DOCKETED	
Docket Number:	11-AFC-04
Project Title:	Rio Mesa Solar Electric
TN #:	233546
Document Title:	Applicant's Supplemental Response to Data Request 16 and 26 Additional Information Regarding Transmission System Engineering
Description:	N/A
Filer:	Marichka Haws
Organization:	California Energy Commission
Submitter Role:	Commission Staff
Submission Date:	6/19/2020 2:45:37 PM
Docketed Date:	6/19/2020

APPLICANT’S SUPPLEMENTAL RESPONSE TO DATA REQUEST 16 AND 26: ADDITIONAL INFORMATION REGARDING TRANSMISSION SYSTEM ENGINEERING

In this section of Applicant’s Supplemental Response to CEC Staff Data Requests 16 and 26, Applicant describes the changes to the Transmission System Engineering section that will result from the changes to the Project Description relating to the removal of Unit 3. Per staff’s request, Applicant uses a strike-out/underline format to identify changes to the Transmission System Engineering section of the Application for Certification that will result from the changes to the Project Description.

Figure 3.4-5

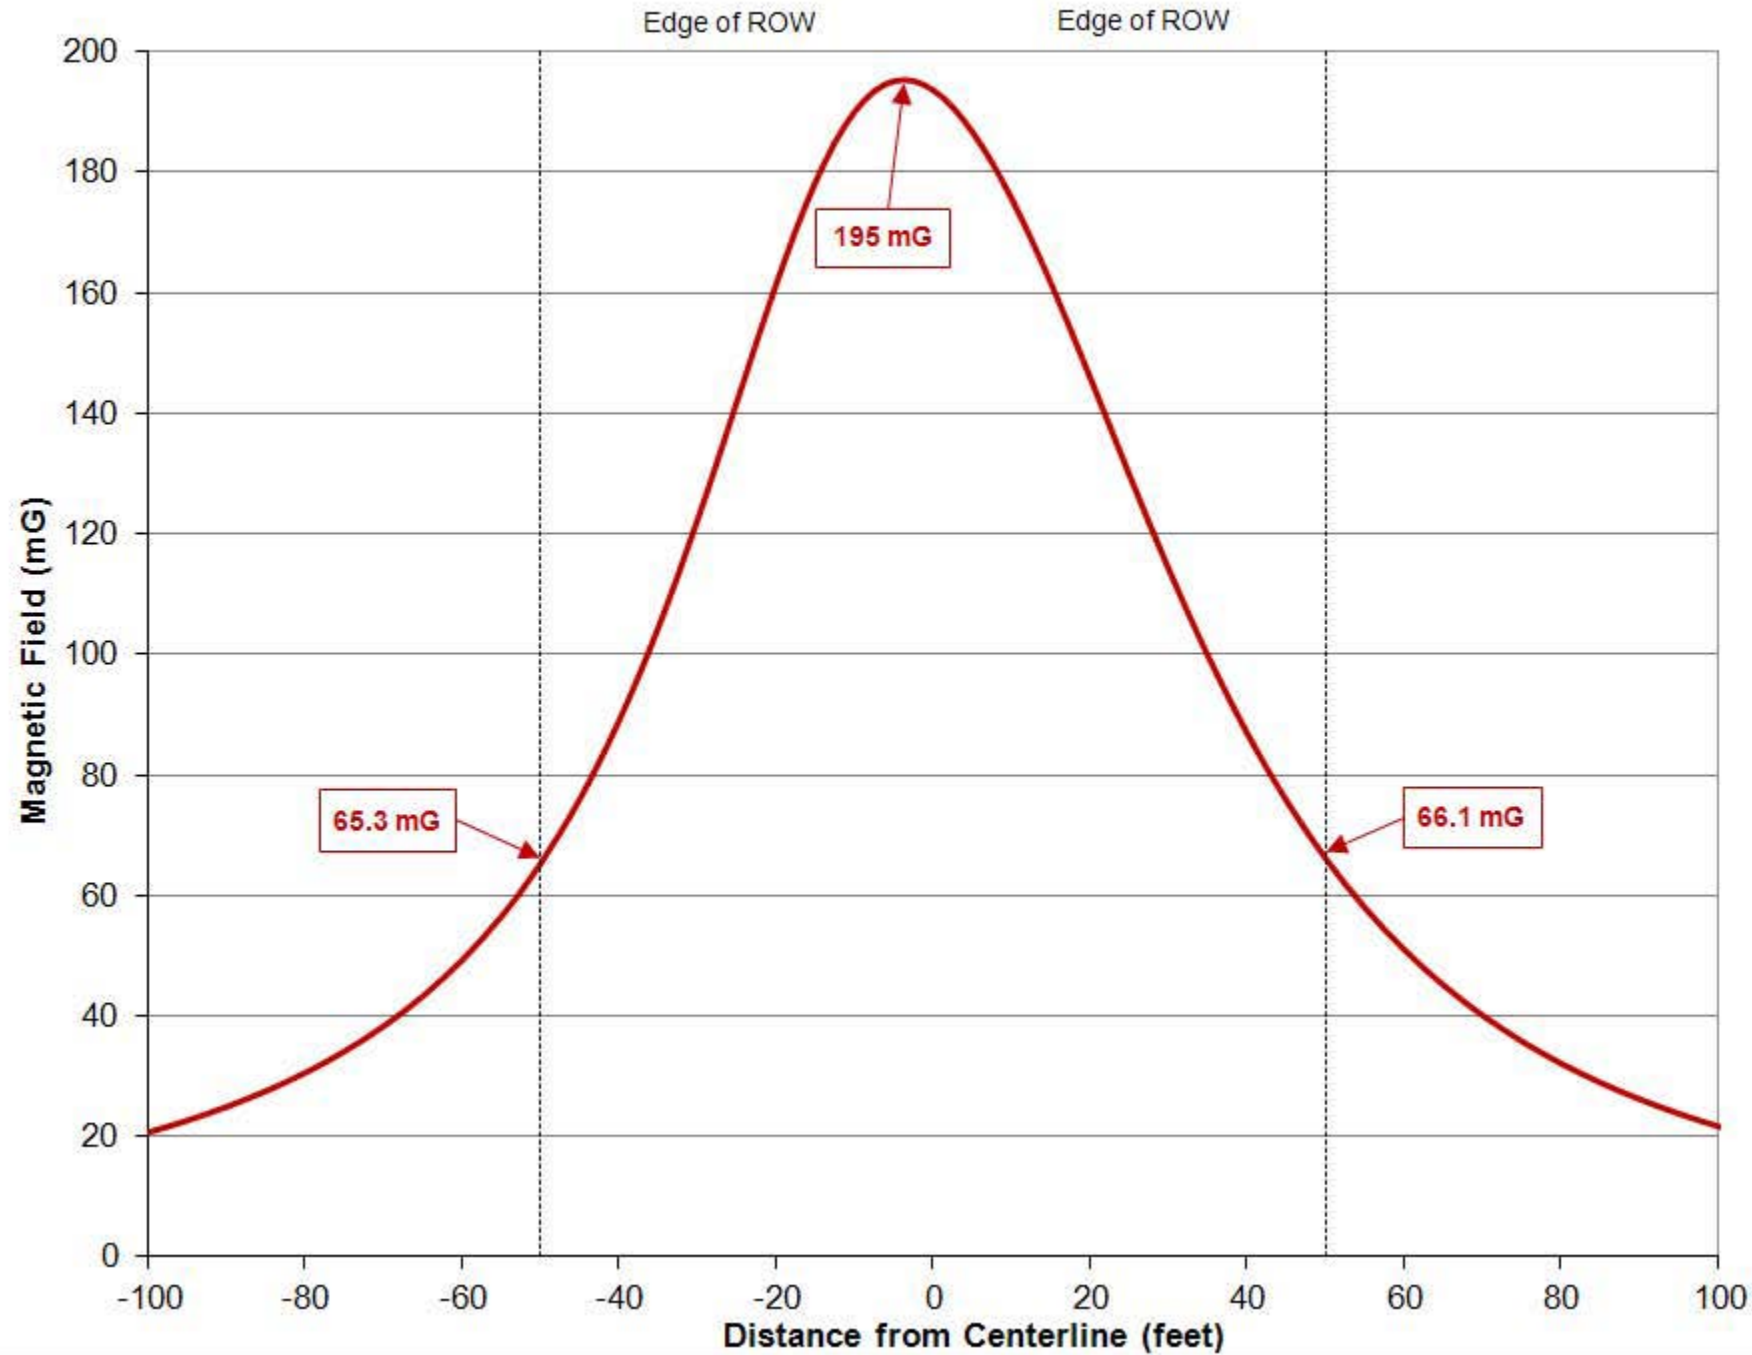
Magnetic Field Line current and arrangement of the phases determine the magnetic field. The magnetic fields of the 220 kV lines are shown in Figure 3.4-5 (rev). Table 3.4-6 summarizes calculated values for the magnetic field at various distances from the center line. The maximum magnetic field for Rio Mesa is ~~120~~95.1 mG at ~~the three feet from the~~ center line as shown in Figure 3.4-5 (rev).

Calculated Magnetic Field Level (mG)	
Distance From Centerline (feet)	Rio Mesa
90-100	9.6 20.6
72-80	16.4 30.5
54-60	29.0 49.2
-50 (Edge of ROW)	65.3
36-40	55.5 89.0
18-20	98.1 161.4
Centerline	120.1 193.6
18-20	98.1 145.9
36-40	55.5 86.8
50 (Edge of ROW)	66.1
54-60	29.0 50.9

<u>7280</u>	<u>46.432.0</u>
<u>90100</u>	<u>9.621.6</u>
